MICROCHIP PIC16F631/677/685/687/689/690

PIC16F631/677/685/687/689/690 Rev. A Silicon/Data Sheet Errata

The PIC16F631/677/685/687/689/690 parts you have received conform functionally to the Device Data Sheet (DS41262E), except for the anomalies described below.

FIGURE 8-2: COMPARATOR C1 SIMPLIFIED BLOCK DIAGRAM

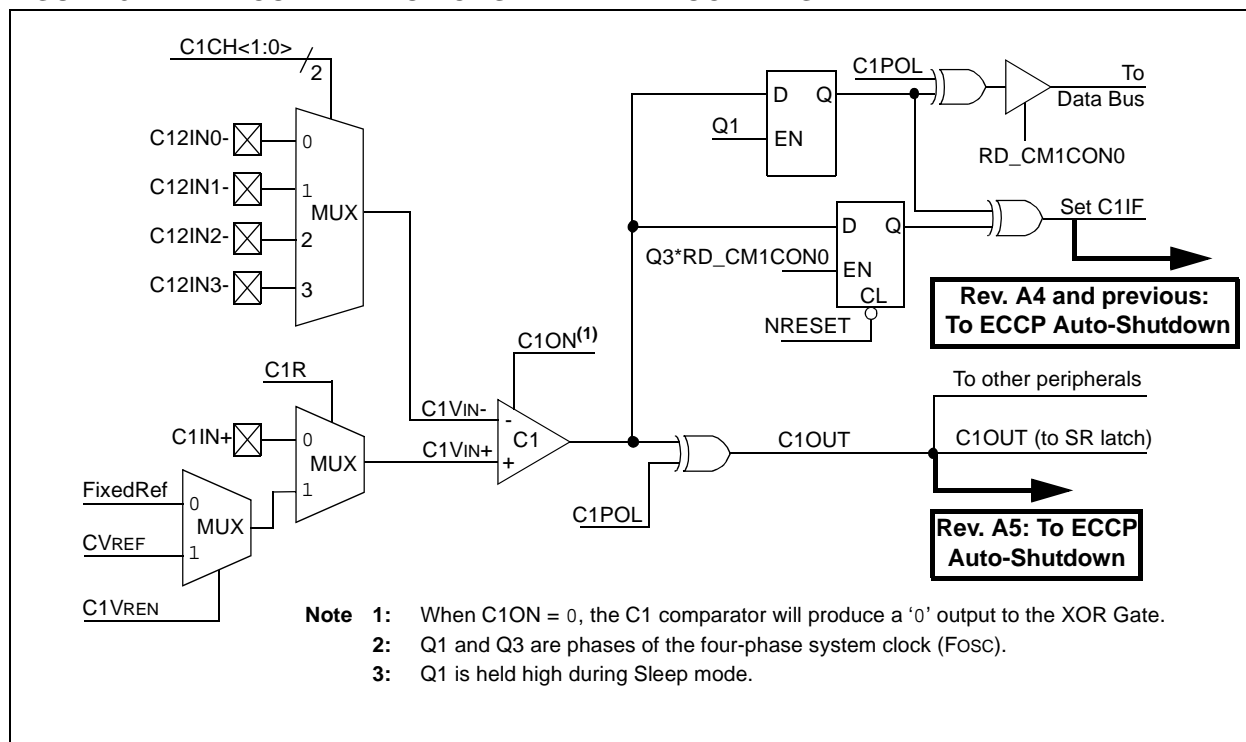
The PIC16F631/677/685/687/689/690 Rev. A4 silicon for the ECCP auto-shutdown is connected to the C1IF and C2IF flags. See Figures 8-2 and 8-3 on the following page.

The auto-shutdown connection (Rev. A4 and previous) to C1IF and C2IF causes the auto-shutdown to incorrectly operate synchronously. Additionally, reads of CMxCON0 will incorrectly clear an auto-shutdown event.

The Silicon Rev. A5 (now shipping) and later revision devices have moved the auto-shutdown connection from CxIF to CxOUT. This will eliminate the synchronous shutdown and simplify the use of the comparator for a shutdown event. Figure 1 shows the function of auto-shutdown before and after the device revision.
